## Proposal for amendments to document GRSG/2023/15 (Supplement 2 to the 01 Series of UN Regulation No. 160 (Event Data Recorder))

The text reproduced below was prepared by the expert from the International Organization of Motor Vehicle Manufacturers (OICA) to adapt the introduction of new verification procedures to the 01 Series of Amendments of the regulation. The modifications to the current text of the proposal by the IWG on EDR/DSSAD (see document ECE/TRANS/WP.29/GRSG/2023/15) are marked in blue bold for new and blue strikethrough for deleted characters.

Corridor  $\pm 10$  Per Cent of the Full Scale Range of the Accelerometer

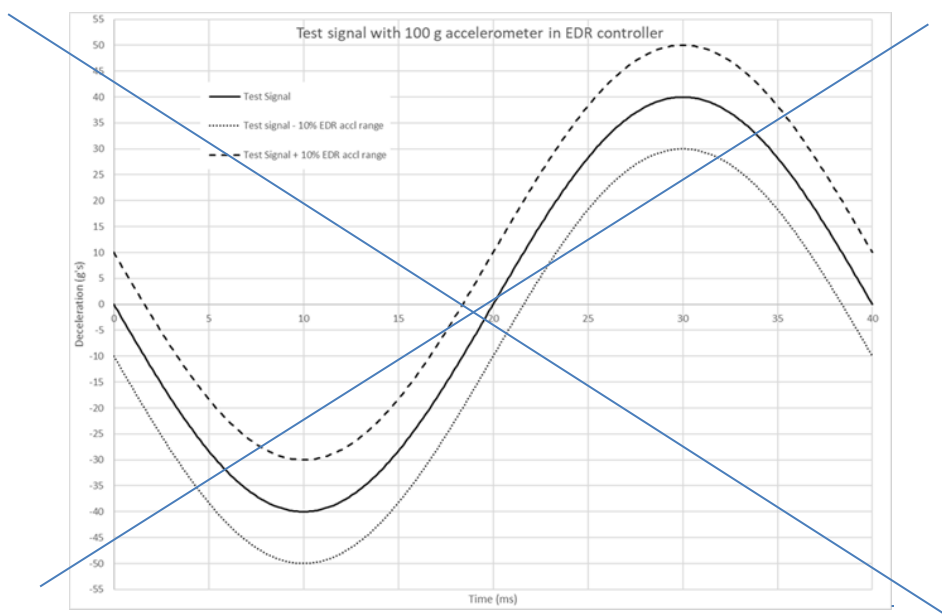
6.1.5. The EDR recorded acceleration trace shall be fully contained in a corridor that is  $\pm 10$  per cent of the full-scale range of the accelerometer used by the controller containing the EDR applied to the component test fixture's filtered acceleration trace. The comparison of acceleration sensor traces shall only be made on the axis the component test was conducted.

For example, if the accelerometer in the controller containing the EDR function has a  $\pm 100$  g range, then  $\pm 10$  g would be applied to the component test fixture's filtered acceleration trace. The EDR recorded acceleration trace shall be fully contained within that corridor (see the Figure).
